**Proposal #10: 5796-00-74, WISC 2023092**  
**Town of Verona, Valley Road**  
**Sugar River Bridge, B-13-0886**  
**Loc Str**  
**Dane County**

This is Addendum No. 01, which provides for the following:

Addendum No. 01  
 ID 5796-00-74  
 Revised Sheet 46  
 November 28, 2022

Addendum No. 01  
 ID 5796-00-74  
 Revised Sheet 55  
 November 28, 2022

QUANTITIES AND NOTES  
 SHEET 2 OF 14  
 46

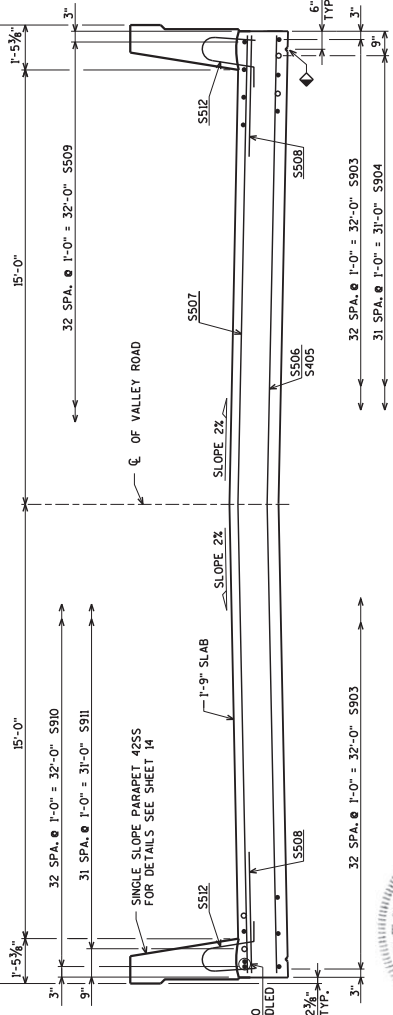
Revised Plan Sheets	
Plan Sheet	Plan Sheet Title (brief description of changes to sheet)
46	Quantities and Notes (revised bar steel quantity)
55	Superstructure (revised bar steel quantity)

NO.	DATE	REVISION
1	11-22-2022	BAR STEEL UPDATE

SHEET 11 OF 14  
**55**  
 SUPERSTRUCTURE

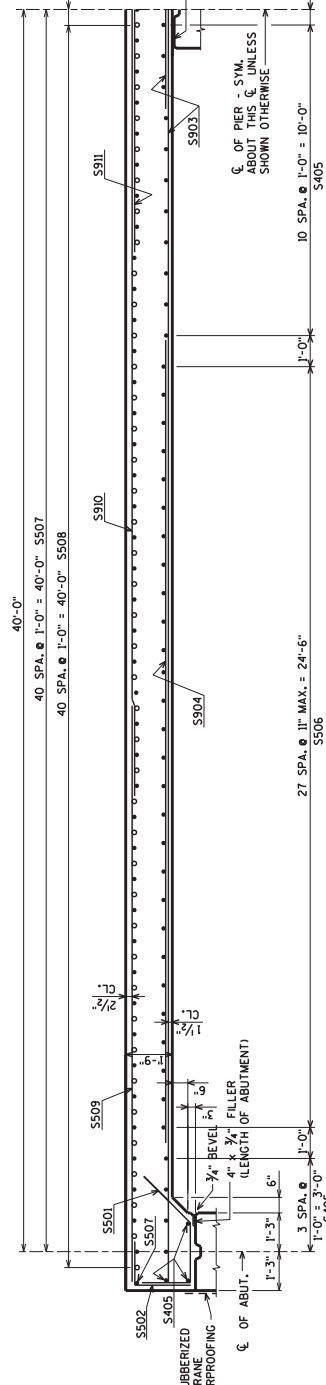
NO. DATE	REVISION	BY
11-22-2022	BAR STEEL UPDATE	DNS
